Re: SDCI #3033991-LU MUP Correction Notice #1–2224 2nd Ave

We have enclosed responses to your correction notice letters for the 2224 2nd Ave Project. The correction items are shown in bold and numbered to correspond with your letter. Each response includes a description of the proposed resolution.

Zoning – Corrections Issued 02/07/2020

CREST & SAG CALCULATOR

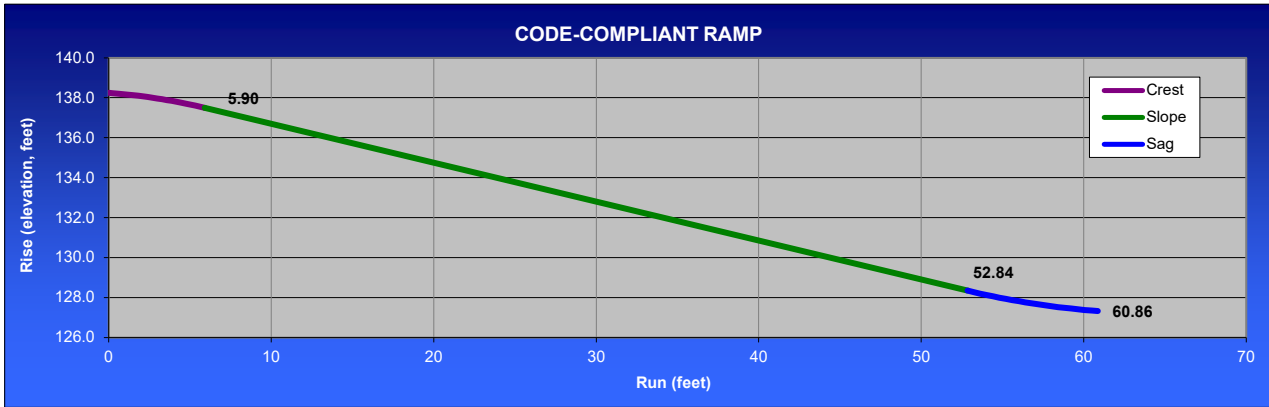
The parking aisle shall not exceed 17% slope per SMC 23.54.030.E.

Please either revise the aisle slope to meet this requirement or provide analysis for a greater slope.

Response: Please see sheet A2.P1 and A2.P2. We have revised the parking aisle slopes in the garage

to be less than 7%. See sheet A2.01. The garage entry ramp is at 19.9%. See enlarged ramp section on

sheet A6.31. We have run a crest and sag analysis to design this ramp. The proposed ramp is beyond

the 15% slope. Per SMC 23.54.030.D.3, we are seeking permission from the Director for this entry

ramp to be more than 15% due to the topography or other special characteristic of the site.

slope @ top 6.0%
 intermediate slope 19.5%
 slope @ bottom 6.0%
 elevation @ top (feet) 138.25
 elevation @ bottom (feet) 127.33

proposed total run (feet) 61.00

Crest	Sag
Code-maximum angle (deg.)	6.4	4.7
Radius of resulting arc (feet)	44.86	60.97
Change in slope	13.5%	13.5%
Angle of slope change (deg.)	7.69	7.69
Length of transition (feet)	5.90	8.02
Height of transition (feet)	0.75	1.02
Resulting length of ramp (feet)		60.86

Proposal is 0.1 feet longer than code-compliant.
